4. **Resolution No. 426. Canyon Creek Subdivision Tract A Open Space.** The applicant is requesting approval of a Site Design Review of Parks and Open Space in the Canyon Creek Phase 3 Subdivision.

**DEVELOPMENT REVIEW BOARD
RESOLUTION NO. 426**

Exhibit A1
Staff Report
Wilsonville Planning Division
Site Design Review of Tract A Open Space
28700 SW Canyon Creek Road South

| Application Nos.: | DB23-0012 Site Design Review of Tract A Open Space - Site Design Review (SDR23-0008) |

Tract A Open Space Location in DB20-0039 et seq

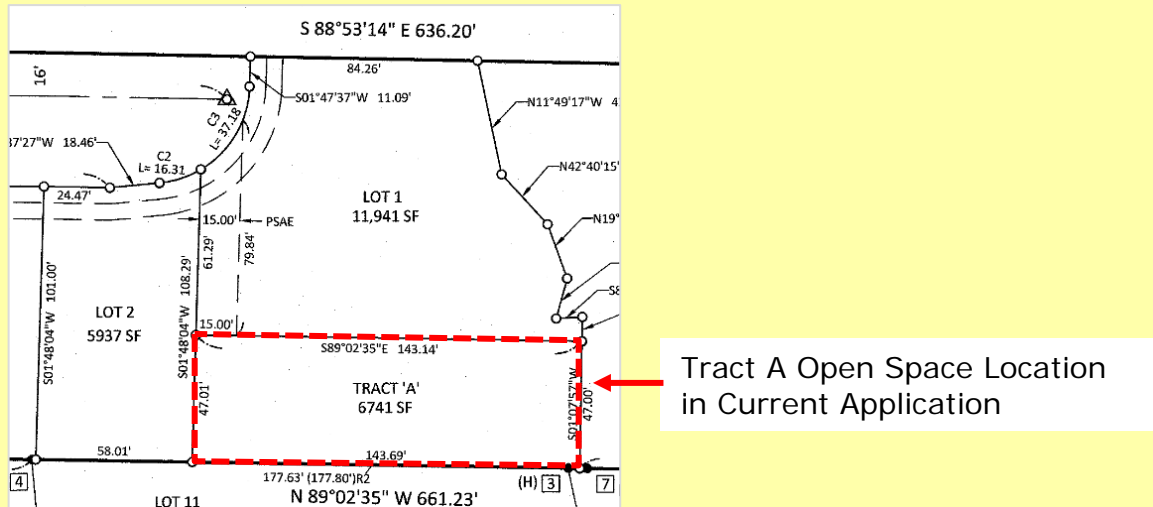
The Canyon Creek South Subdivision was approved as a five (5)-lot residential development with a required open space area (Tract A) in April 2020, Case File No. DB20-0039 et seq. When the staff report was prepared for the Development Review Board (DRB) public hearing, only the size and general location and shape of the required usable Tract A open space area had been submitted by the applicant, as shown in the illustration below.

In response to public testimony received and subsequent discussion by the DRB at the hearing, Condition of Approval DRB 1 was added requiring the plans to be updated to swap the location of the Tract A open space with Lot 1, as illustrated below and proposed in the current application.

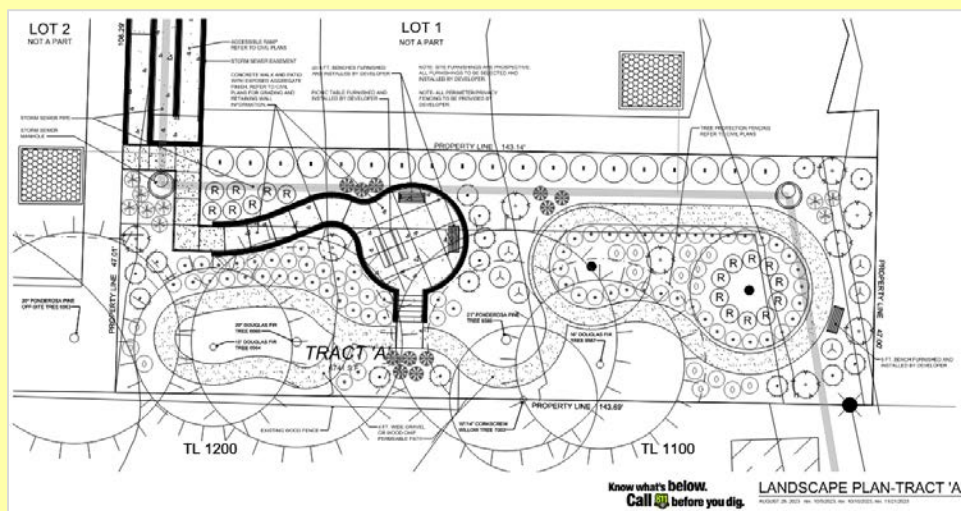
As demonstrated in the Findings, the Tract A open space, shown below and in the applicant's submitted plans (Exhibit B2), has been designed by a registered professional landscape architect and conforms with the Site Design Review criteria for open space in residential subdivisions.
